BIDS AND AWARDS COMMITTEE

**SUPPLEMENTAL BID BULLETIN NO. 1
 SUPPLY, DELIVERY, INSTALLATION AND TESTING OF VARIOUS HEATED AIR
 MECHANICAL GRAIN DRYERS
 (PHilMech-RCEF-23-09-22)**

This **Supplemental/Bid Bulletin No. 1** is being issued to clarify, amend and supplement provisions in the Bidding Documents.

Annex A. Single line diagram sample

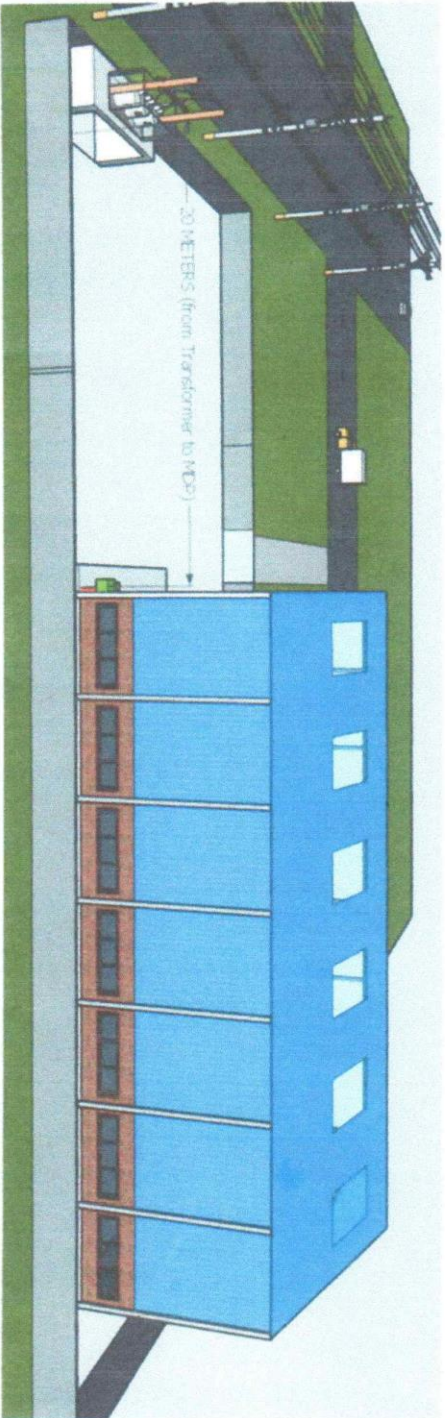
<i>Action Taken/Reply: Please refer to item No. 2</i>		
<i>5. Issue / Proposal: Manifestation that their offered 12tph dryer requires 3-phase transformer</i>		
<i>Action Taken/Reply: Please refer to item No. 2</i>		
<i>6. Issue / Proposal: Request for the electrical/schematic diagram from transformer to the building</i>		
<i>Action Taken/Reply: Single line diagram sample is hereby attached as Annex A.</i>		
<i>7. Issue / Proposal: Request to consider the type of the transformer required</i>		
<i>Action Taken/Reply: Please refer to item No. 2</i>		
<i>8. Issue / Proposal: Request that the material be SS-301 minimum since it is still food grade.</i>		
<i>Action Taken/Reply: Please refer to item No. 1</i>
